ADDENDUM 3

Contract: 24-C-00032; TPD Howard Avenue Annex Building

## City of Tampa | TPD Howard Avenue Annex Building

### Revision 3, CoT Addendum 3 – Bid RFI Responses

4 COAX RISER DIAGRAM  
12" = 1'-0"

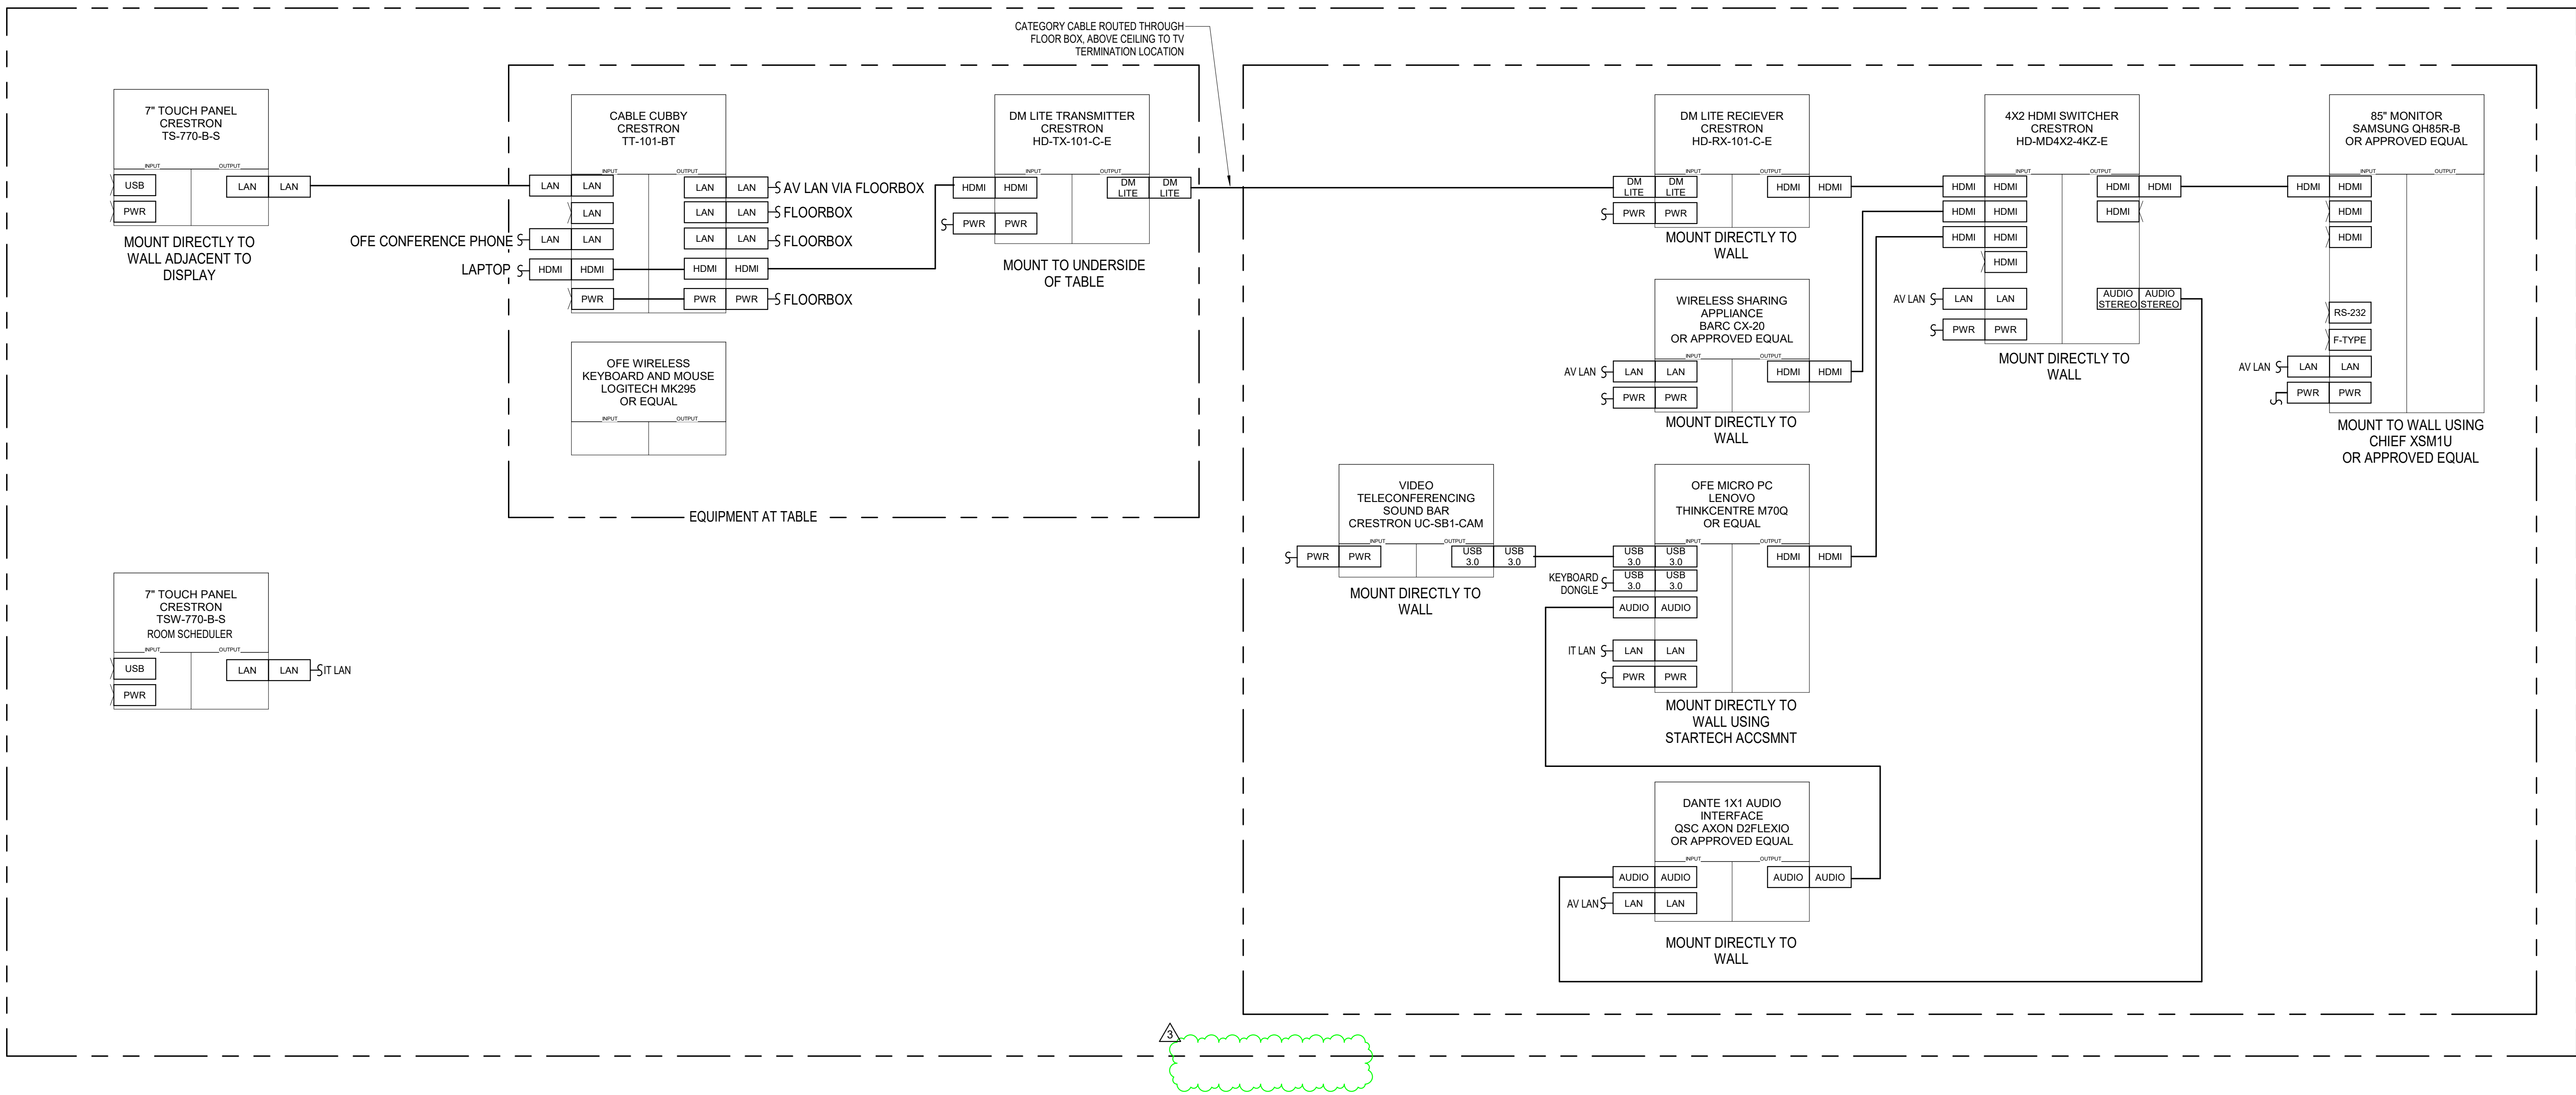
- Equipment to support rack indicated.
- Category cable to TV locations indicated.

5 (Kokolakis #007)	11/18/2025	Kokolakis	Cable type for TV drops	The TV Detail on T721 shows a single Category 6A cable, but the Coax Riser on T601 shows RG6. Please clarify which type of cable is required for the TV drops.	TLC	TLC will update drawings for response. Sheet(s) should be re-issued as part of "REV 3, CoT ADDENDUM 3, 11/26/2025".	TLC - DISPLAYS SHALL RECEIVE BOTH AS COAXIAL (RG6 OR RG11) AND A DATA CABLE. See revised sheet "T601 - VOICE/ DATA RISER DIAGRAMS"	11/25/2025	CLOSED
6 (Kokolakis #008)	11/18/2025	Kokolakis	Room 171 data rack connection	There is a separate data rack in Room 171, but there is no Backbone Riser or Rack Elevation shown for that rack. Could you please confirm what is required to connect this rack to the Main IDF?	TLC	TLC will update drawings for response. Sheet(s) should be re-issued as part of "REV 3, CoT ADDENDUM 3, 11/26/2025".	TLC - PROVIDE 12 STRAND SM FIBER IN 2" CONDUIT BETWEEN IDF AND RACK LOCATION.	11/25/2025	CLOSED
